**Amendments to the Drawings:**

FIG. 7

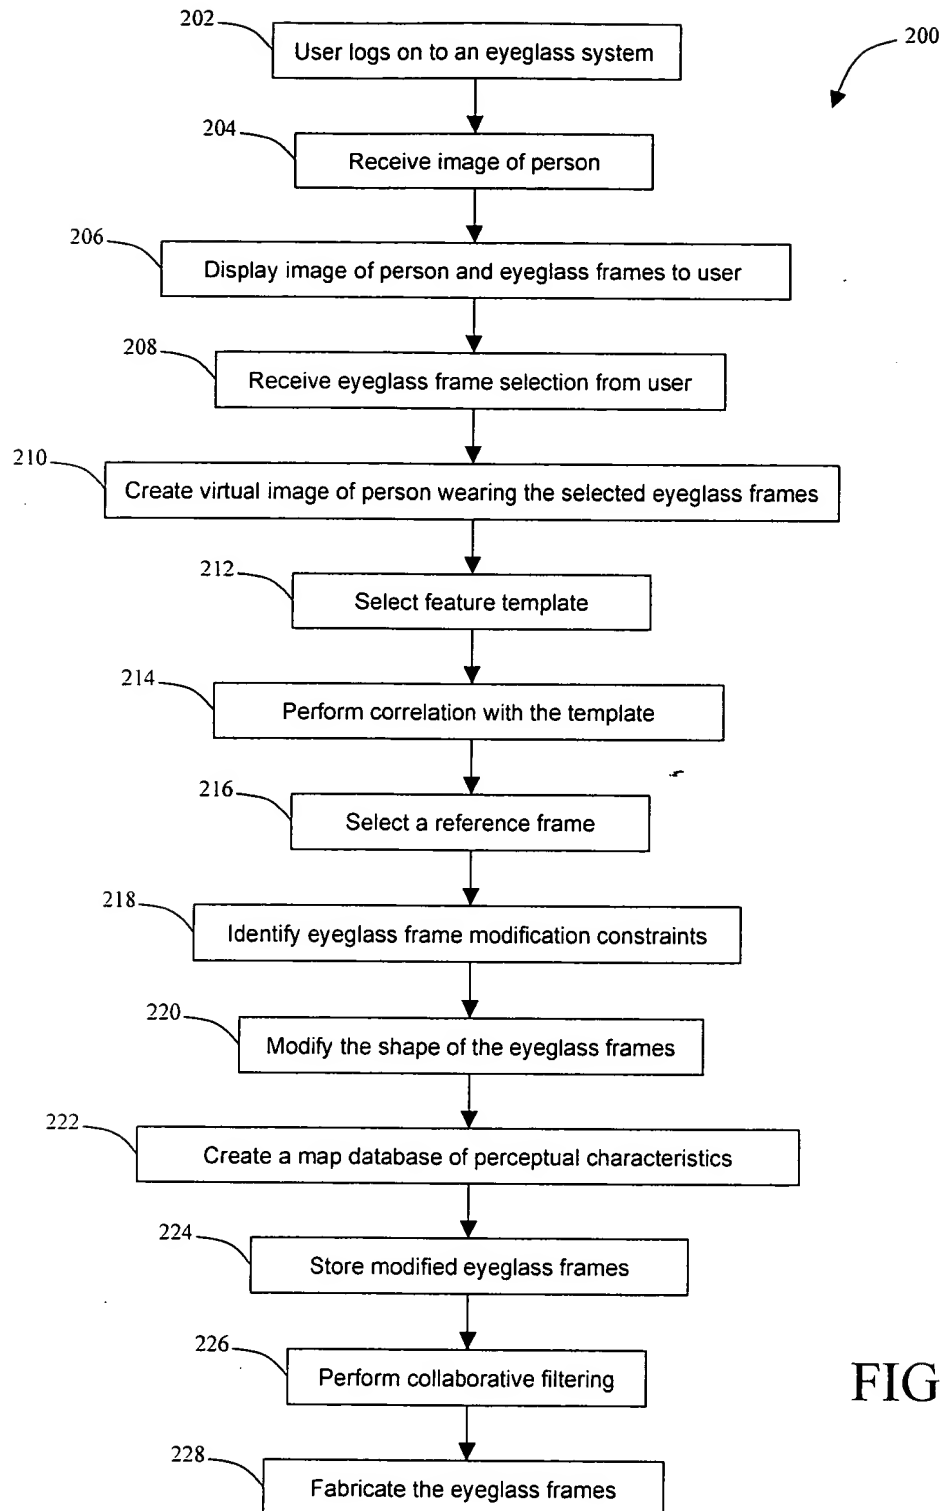
The Examiner objected to the Fig. 7 of the drawings under 37 CFR 1.84(h)(5) because Figure 7 show(s) different use of “frame” in the same view. The Examiner stated that it is not clear whether the “frame” used in all of the steps of Fig. 7 are the same or different from “glass frame” used in step 228. The Examiner required the submission of corrected drawing sheets to avoid abandonment of the application.

In response to the Examiner’s objection to Fig. 7 of the drawings and requirement for corrected drawing sheets, Applicant submits with this Amendment and Response to Office Action the attached Replacement Sheet for Fig. 7 of the drawings, which clarifies the “frame” used in all of the steps of Fig. 7.
